**Wastewater System for Proposed Ablution Block**  
**U071312**  
**Our ref B07-2101 / 0333**

**Receipt of application for resource consent - U071312 - Bradley,  
Micheal Kenneth David & Lynette Carol - Queen Charlotte Drive  
Havelock**

# Engineering Report

**On-Site Wastewater Management**

AMENDMENT	DATE	DETAILS	PROJECT <b>BRADLEY ABLUTION BLOCK</b>	 <small>ENGINEERING   RESOURCE MANAGEMENT   ARCHITECTS</small> <small>TEL 03 579 6211 FAX 03 579 6233 PO BOX 546 BLENHEIM NEW ZEALAND</small>	DWG NO. 0333-002	AMENDMENT
			DRAWING DRAINAGE FIELD SPECIFICATION		CAD FILE REF:	DRAWN DD

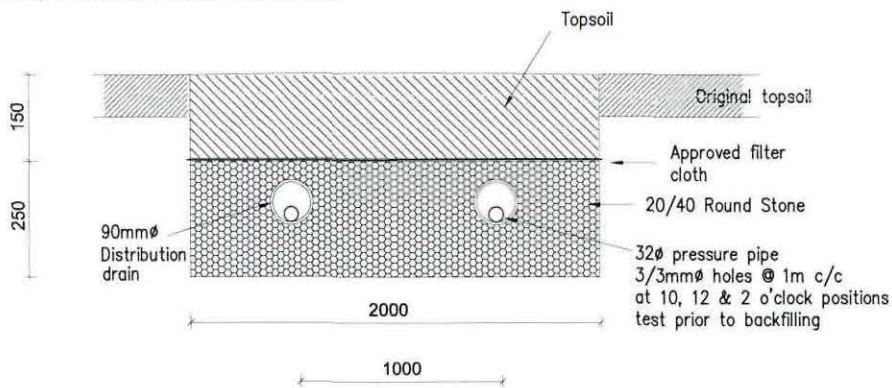
- The wastewater loading assessment is not accurate and not acceptable. The system has to be designed for the maximum loading proposed – this is 6170 litres a day according to my calculations – 40 people camping at 130 litres a day (as showers and kitchen are provided), 4 people residing at 180 litres per day, and 10 people using the shop at 25 litres per day. This totals 6170 litres per day. The design that has been provided is insufficient for this loading.

On the basis of the assessed design flow of 1,250 litres per day and adopting a loading rate of 15mm/day, the total length of 2.0m wide shallow bed required is 42m (refer attached wastewater design sheets). It is recommended that this length of bed be constructed as 3 beds of 14m. A recommended bed detail is provided on the attached drawing 0333-002.

SITE PLAN	28 NOV 2007	DRAWING No. 001
DRAWN DD	CHECKED JD	DATE 20.04.07
COMPUTER FILE: drawings\	SCALE (A3) 1:750	REVISION /

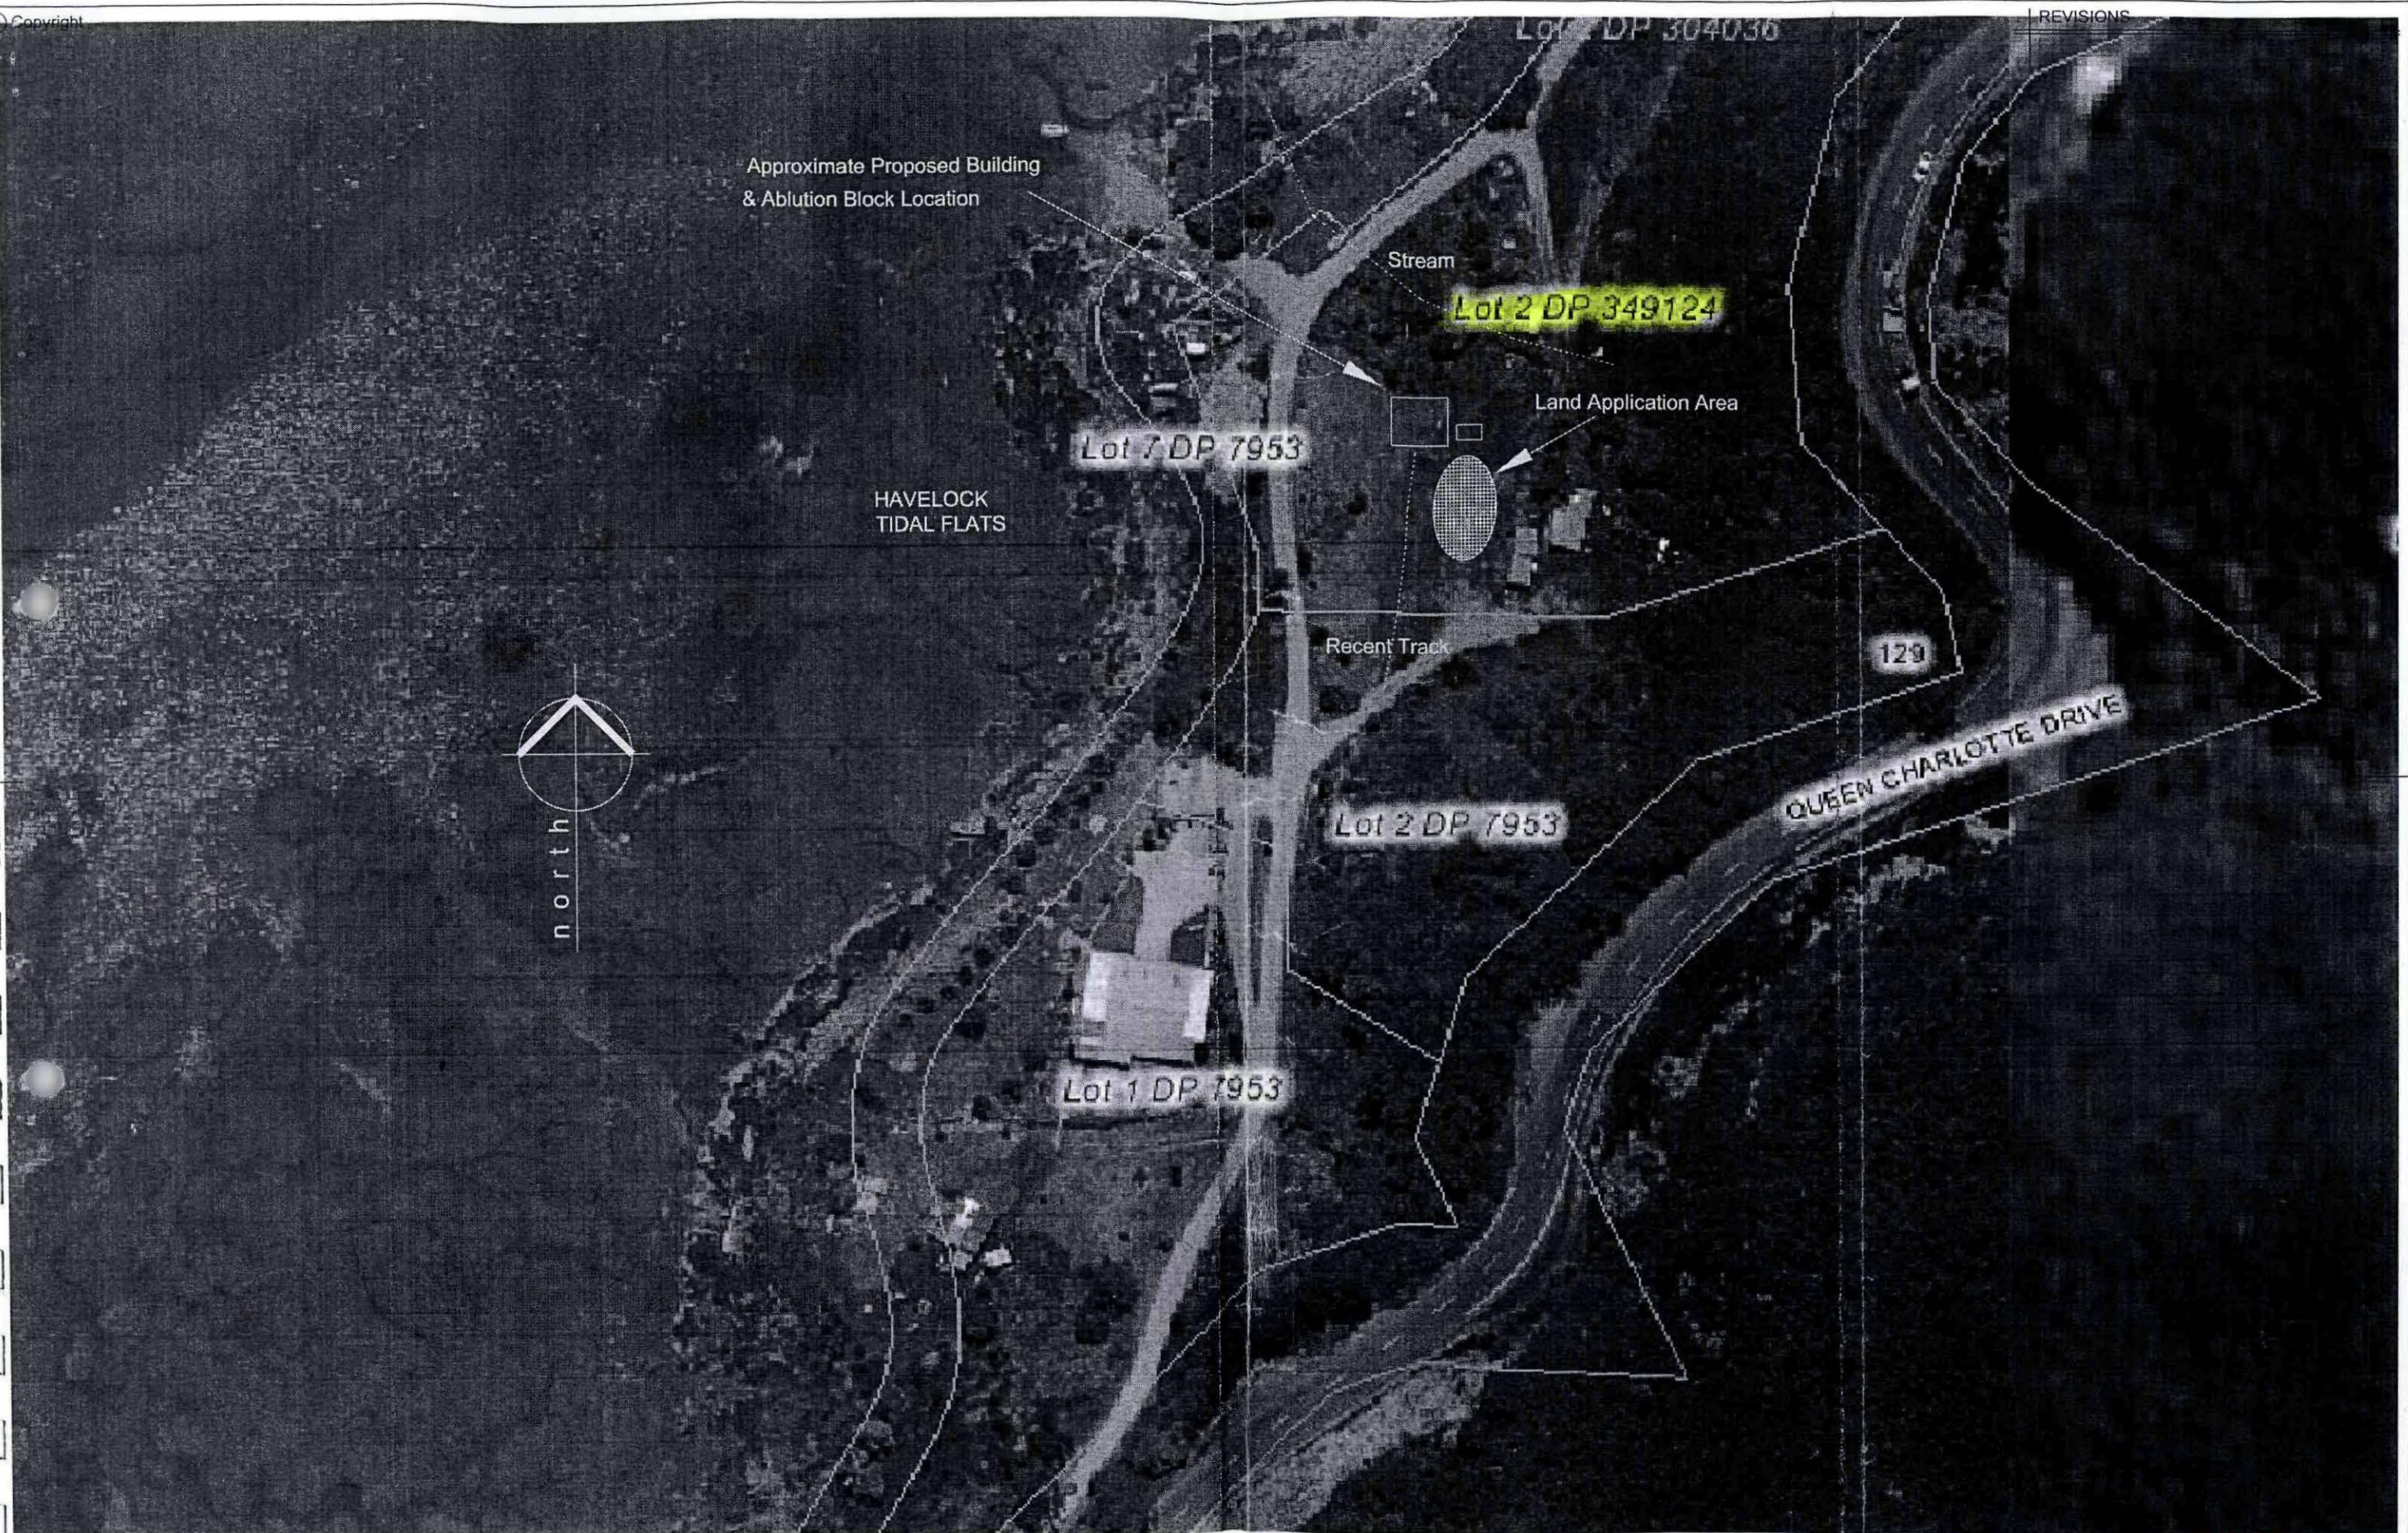
- The location of the soil testing has not been provided on the site plan. This must be done within the proposed land application area – please provide evidence of where in the LAA that this was done.

Please find attached a revised site plan showing the locations of the wastewater field auger locations W1 and W2 and log L1 of the exposure in the existing track.
